**RE: RESPONSE TO INFORMATION REQUEST FOR OPW/2020/650  
EXTERNAL WATER MAIN RELOCATION ASSOCIATED WITH STAGE 1 OF THE  
VANTAGE, YATALA INDUSTRIAL DEVELOPMENT**

**Property: Lot 501 on SP295994 – 60 Stapylton Jacobs Well Road Stapylton QLD**

We act on behalf of the Applicant, Frasers Property Australia Pty Ltd, and provide the following response to Council's Information Request dated 8 June 2020. Given the nature of the response, the Applicant considers this to be a full response to the information request.

TYPICAL TRENCH DETAIL (TYPE C) UNDER  
SIGNALISED INTERSECTION PAVEMENT

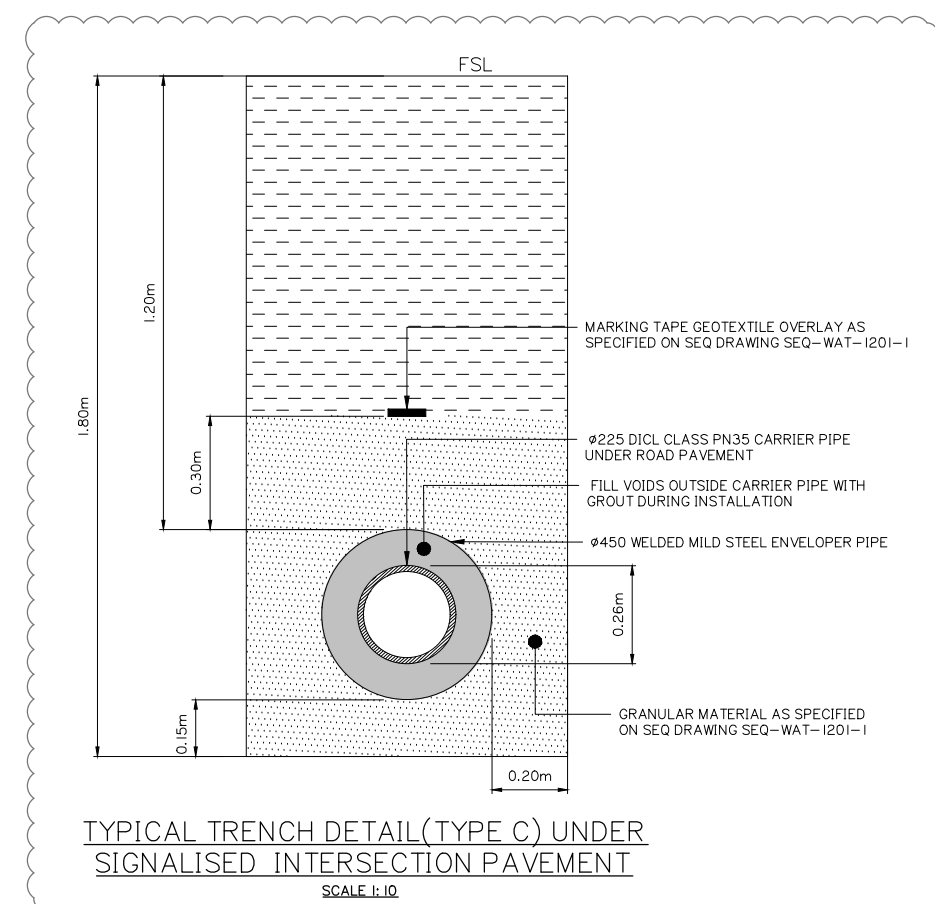
- 6      *The trench detail under signalised intersection pavement must show 300 minimum pipe embedment above the pipe due to being trafficable as per standard drawing SEQ-WAT-1202-1.*

The trench detail on drawing 004 has been amended to incorporate Council's request of 300mm minimum pipe embedment above the pipe. The revised engineering drawing set containing this updated plan is contained with **Attachment 3**.

| 5941 ENG SJW WAT 006 | A        |

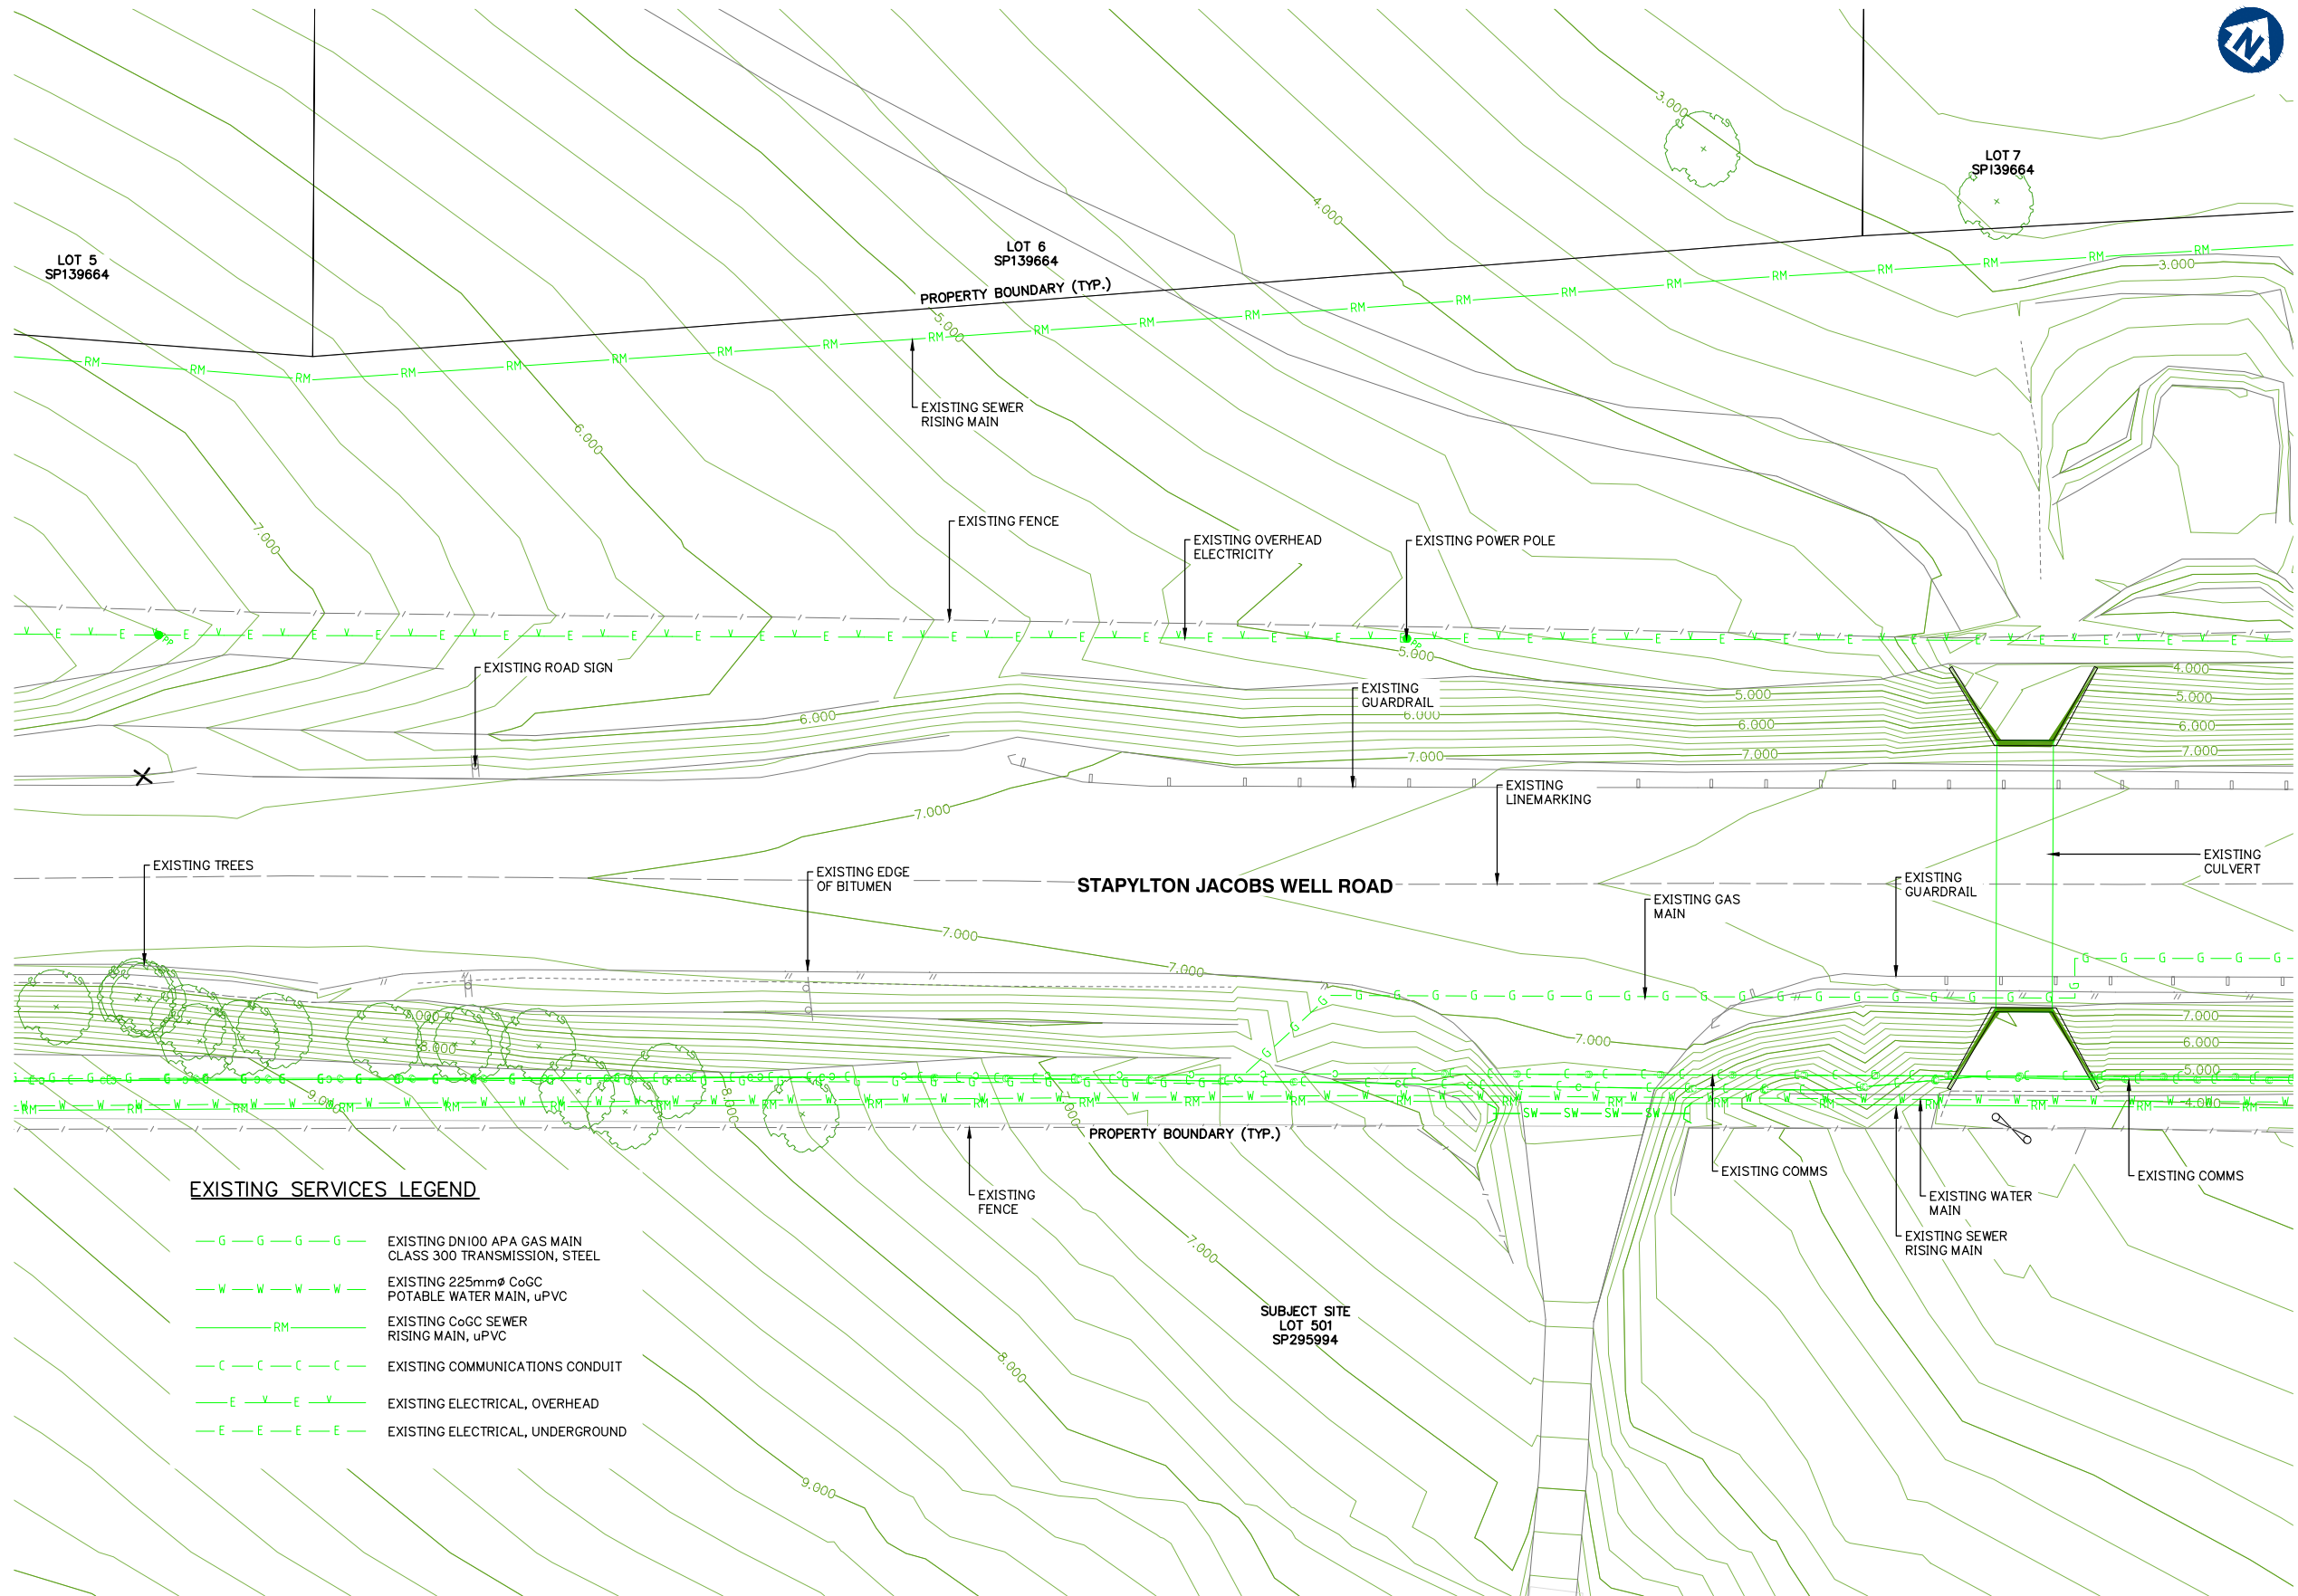
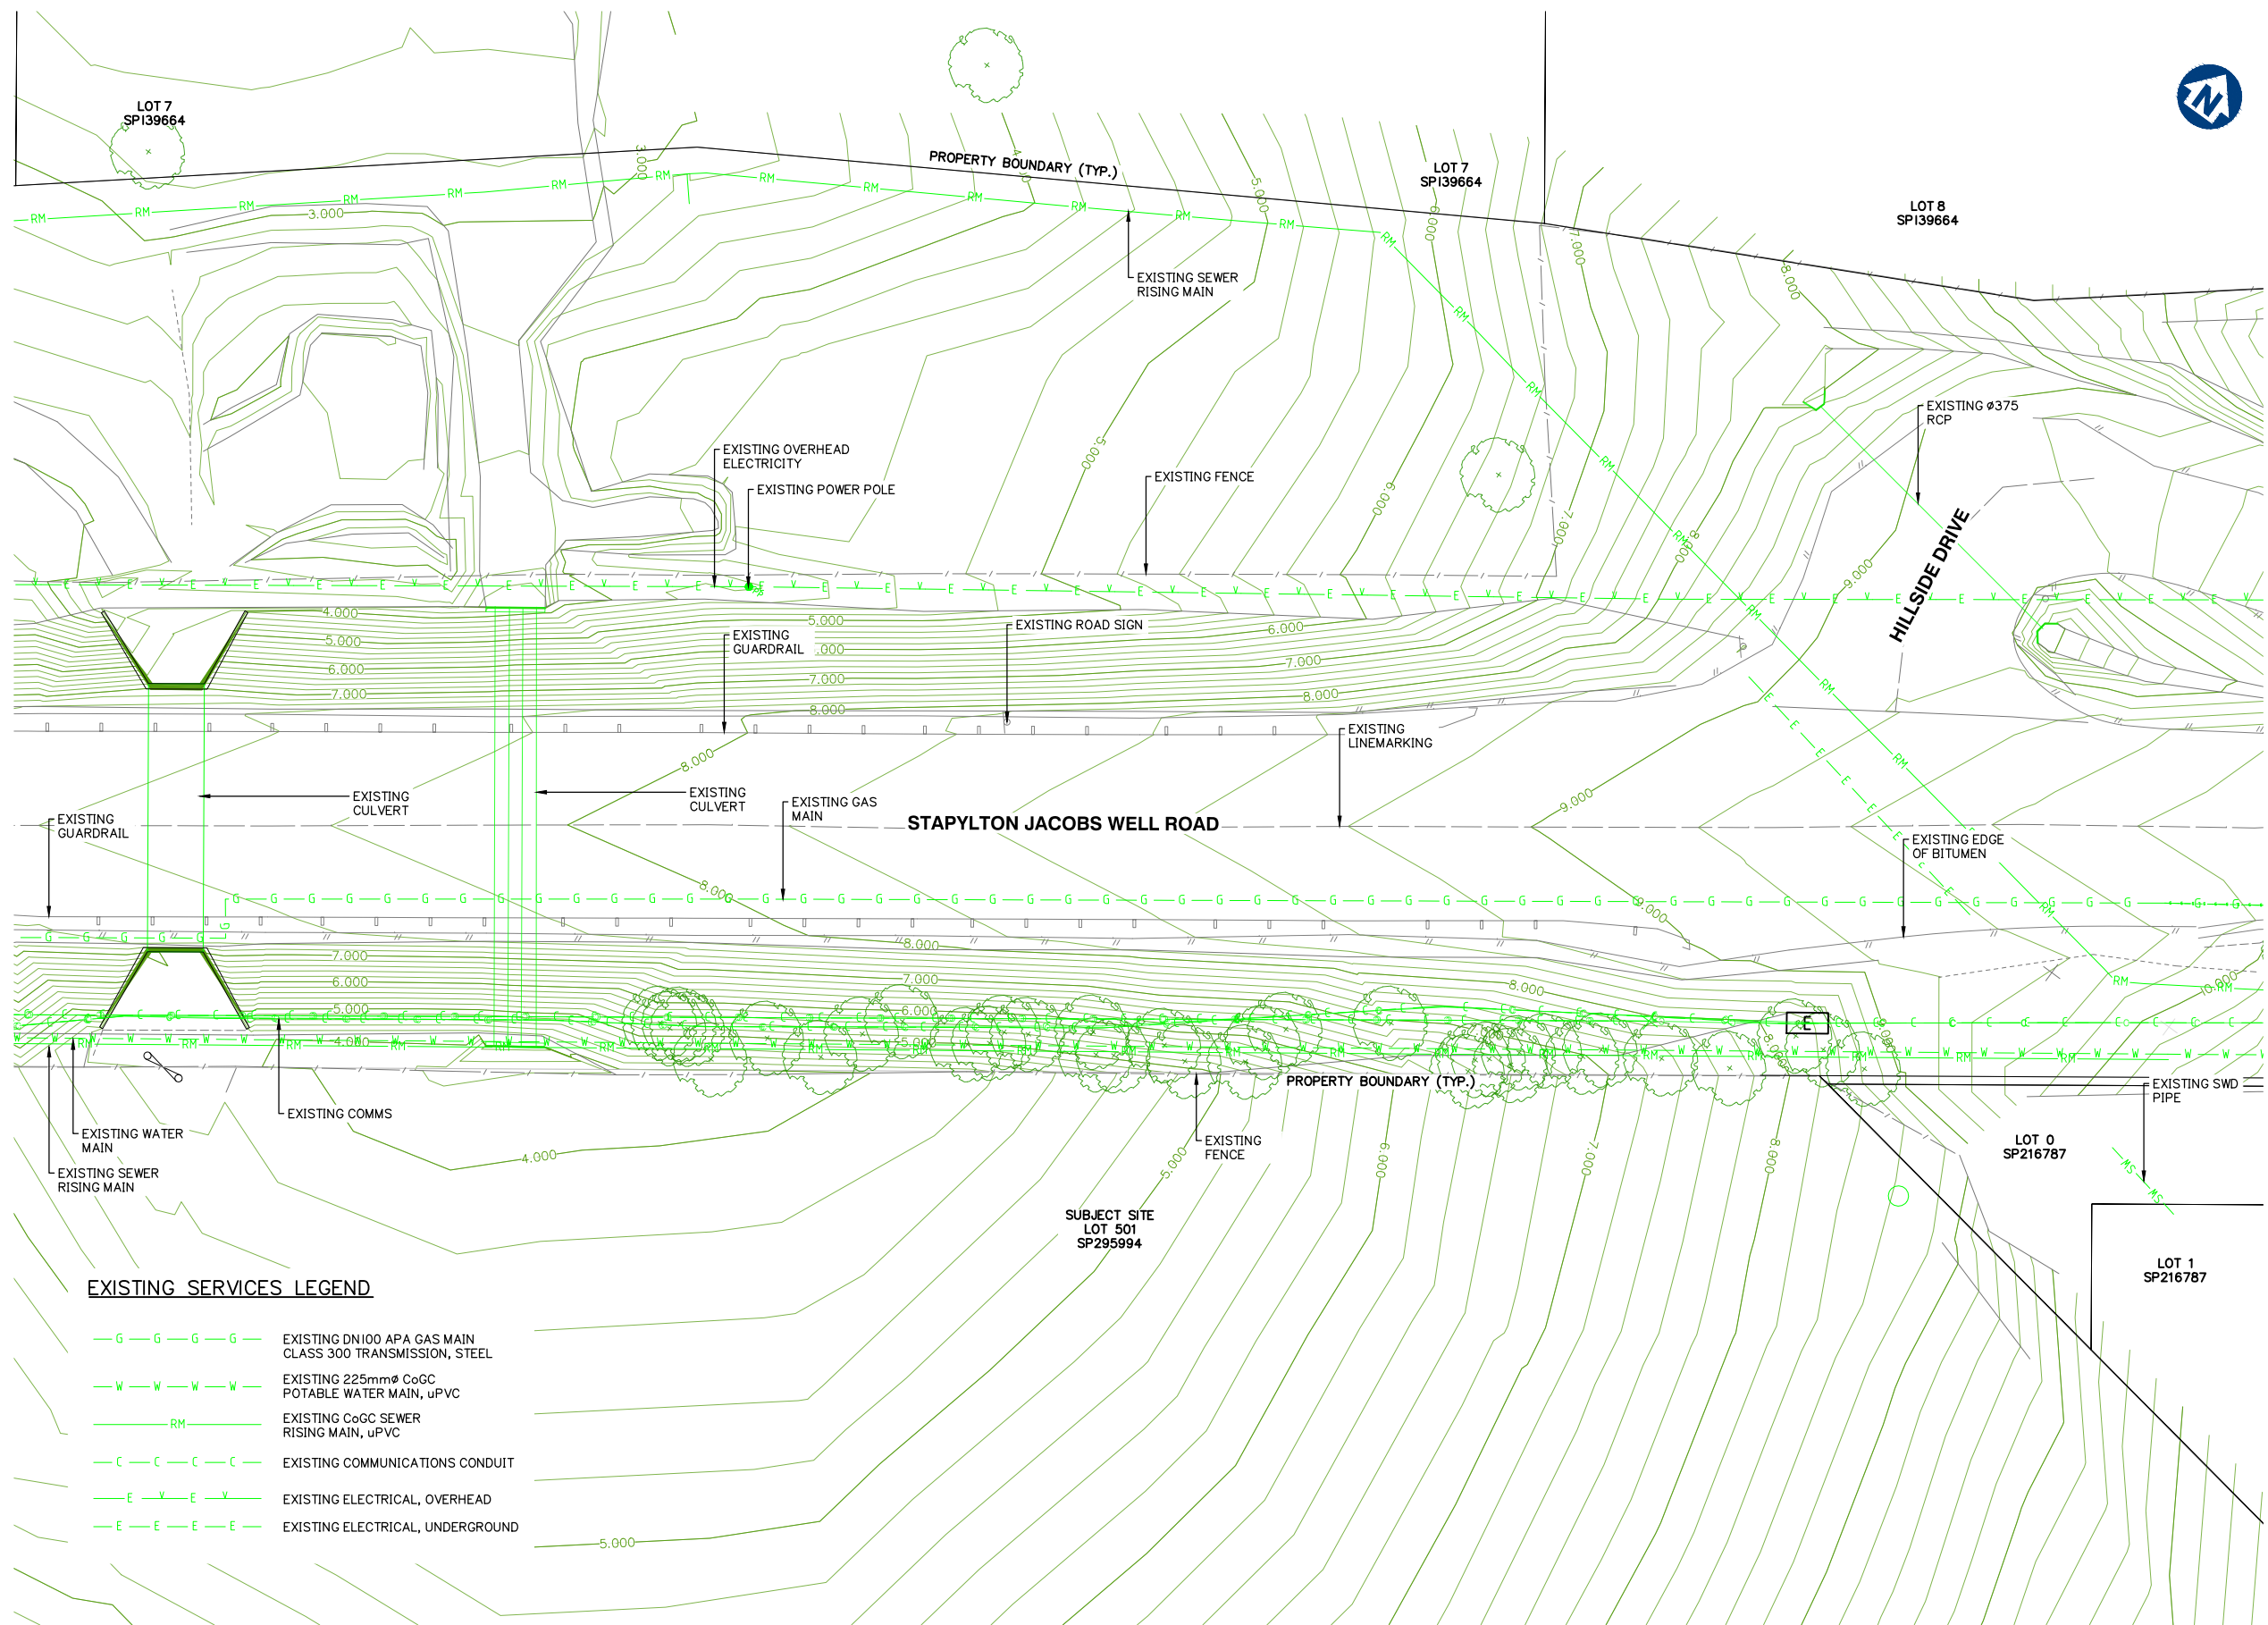
- 7      *Update Section 1 notes regarding the watermain to abandoned following confirmation from TMR that it can remain in place, rather than removed.*

The Section 1 notes regarding the watermain demolition / abandonment have been updated to reflect DTMR's advice. The revised engineering drawing set containing this updated plan is contained with **Attachment 3**.
